Product consolidation RIDERSERIES RCI relays

Type of notification: ☒ PCN ☐ PDN ☒ Short-term action (<6 months)

Versions without test button:

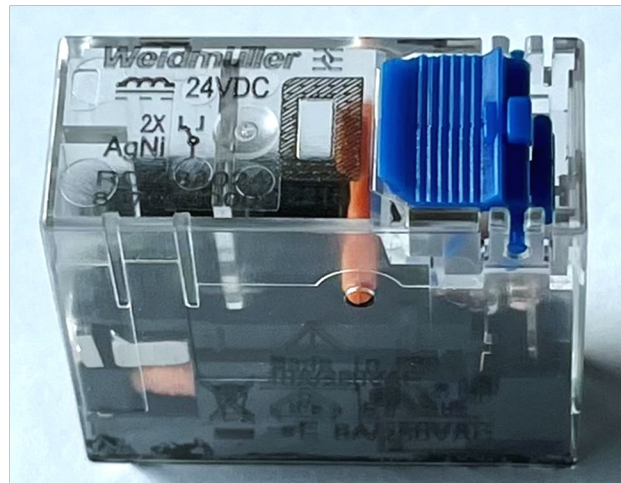
- Changeover of printing from pad printing to laser printing
- Color coding of the coil voltage:
 - o Is removed for the variants without test button
 - o Is done via the color of the test button for the variants with test button (AC: red / DC: blue)

The adjustment has no effect on the performance or technical data of the products.
It is a visual adjustment only.
